SUNDRY NOTICES AND REPORTS ON WELLS (DO NOT USE THIS FORM FOR PROPOSALS TO DRILL OR TO DEEPEN OR PLUG BACK TO A DIFFERENT RESERVOIR. USE "APPLICATION FOR PERMIT" (FORM C-101) FOR SUCH PROPOSALS.)		WELL API NO. 30-025-42087
1. Type of Well: Oil Well ☒ Gas Well ☐ Other ☐		5. Indicate Type of Lease STATE ☒ FEE ☐
2. Name of Operator EOG Resources, Inc.		6. State Oil & Gas Lease No.
3. Address of Operator P.O. Box 2267 Midland, TX 79702		7. Lease Name or Unit Agreement Name Hearns 27 State Com ✓
4. Well Location Unit Letter N 210 feet from the South line and 1360 feet from the West line Section 27 Township 24S Range 33E NMPM County Lea		8. Well Number 504H ✓
11. Elevation (Show whether DR, RKB, RT, GR, etc.) 3480' GR		9. OGRID Number 7377 ✓
		10. Pool name or Wildcat Triste Draw; Bone Spring, East

EOG Resources requests an amendment in our approved APD for this well to reflect a change in SHL & BHL.

Well Name: Hearn's 27 State Com No. 504H

Hearns 27 State Com #504H

Proposed Wellbore

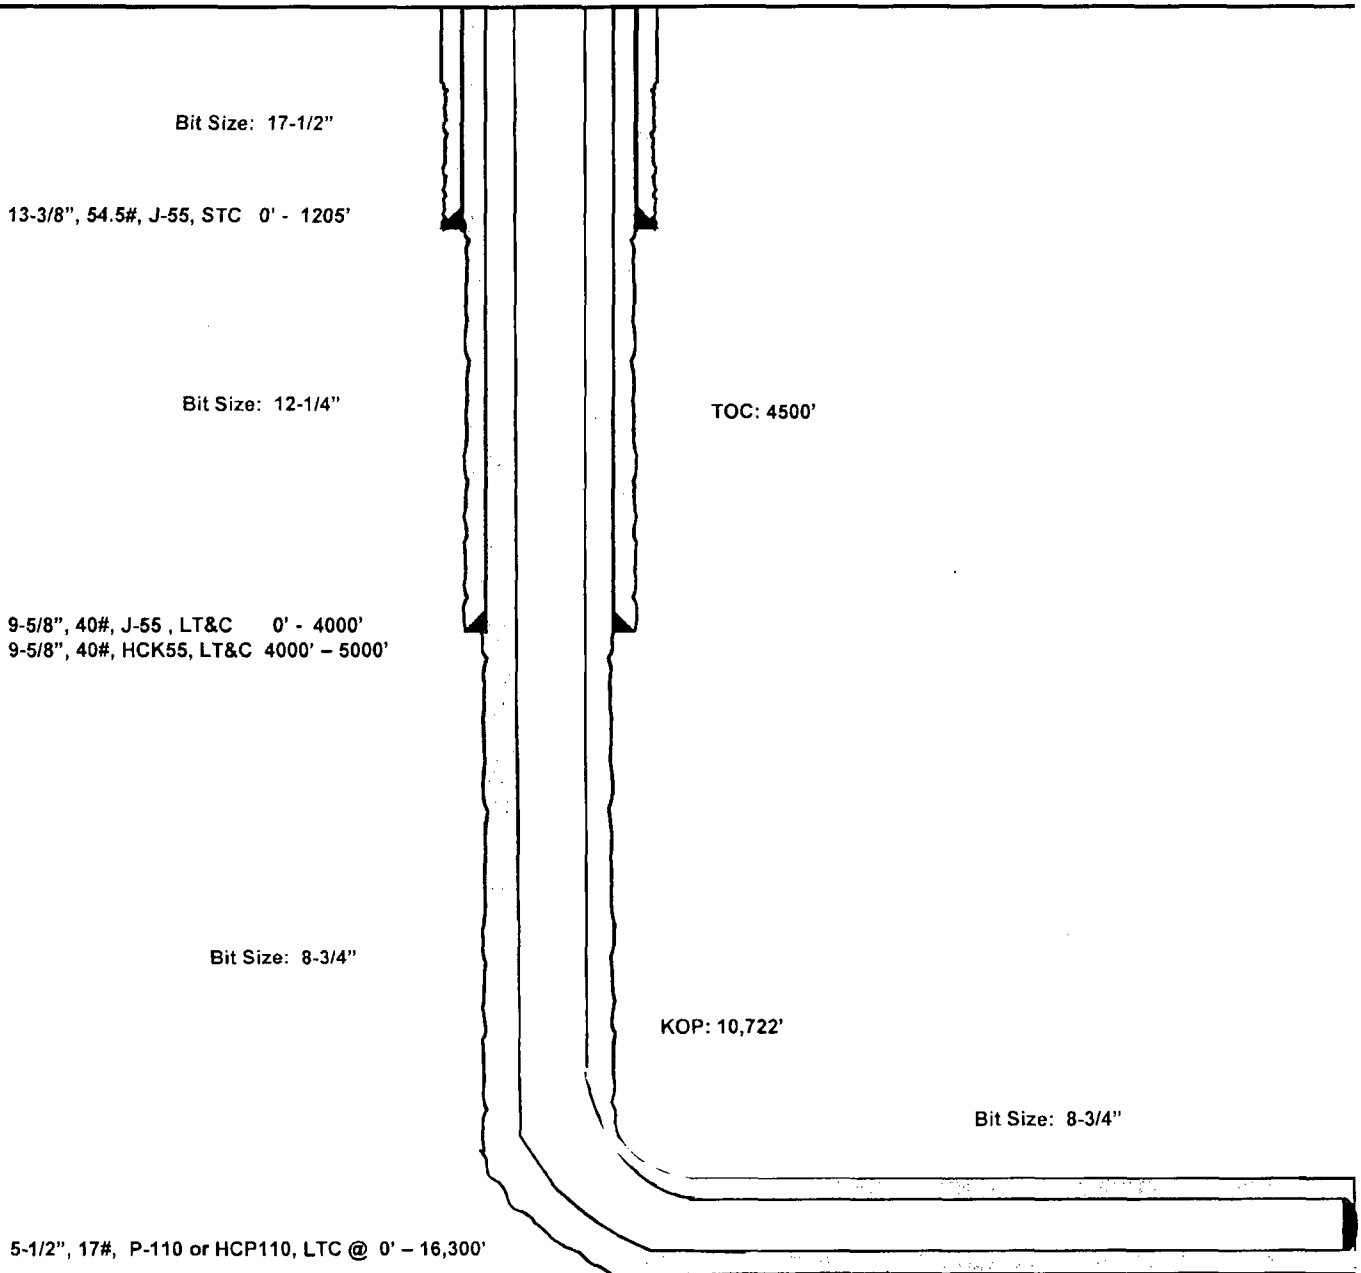
SHL change from 210' FSL & 1350' FWL TO 210' FSL & 1360' FWL, Sec. 27-24S-33E
BHL change from 230' FSL & 1505' FWL TO 230' FSL & 1700' FWL, Sec. 34-24S-33E

Change TMD from 16264' to 16300'. TVD same at 11200'.

Lateral: 16,300' MD, 11,200' TVD

BH Location: 230' FSL & 1700' FWL
Section 34
T-24-S, R-33-E
